VENDOR SERVICE PUBLICATION

Subject: Garrett AiResearch Manufacturing Company of California
Service Bulletin No. 5-2294, Revision No. 1, dated December 15, 1980.
("Outflow/Safety Valve - Inspection for Suspected Faulty Poppet")

PA-31T Cheyenne II

OUTFLOW/SAFETY VALVE - Inspection for suspected faulty poppet

Typical Outflow/Safety Valve
Figure 1

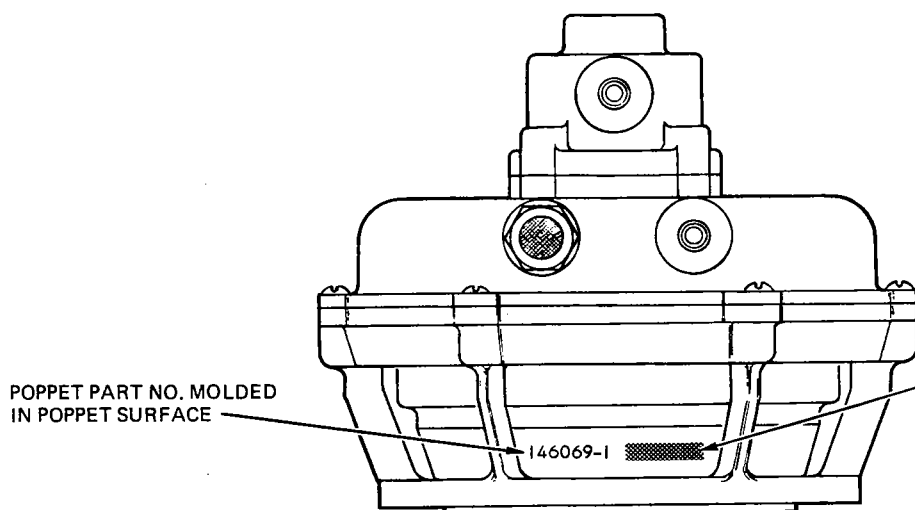
- (1) Inspect all installed outflow/safety valves as follows:
 - (a) Visually check the functional test (FT) date appearing on cover of outflow/safety valve (see figure 1) to determine if the FT date falls between 1 January 1980 through 31 Aug. 1980. If the FT date is not within these dates and no physical damage is apparent, no further action is required and outflow/safety valve is considered serviceable.

- (b) If check of the FT date is between the specified date of 1 January 1980 and 31 August 1980, perform check of poppet assembly to determine if a date stamp appears on surface of poppet (figure 1), or if poppet is fractured. If poppet does not have a date stamp, remove and replace the outflow/safety valve within 100 flight hours after receipt of this bulletin. If poppet is fractured, remove and replace defective outflow/safety valve prior to next flight. Return outflow/safety valve to Piper Aircraft for replacement.
- (c) If check of poppet assembly reveals a date stamp on poppet, regardless of an FT date within 1 January 1980 through 31 Aug. 1980, the poppet assembly is considered servicable and outflow/safety valve can remain in use.
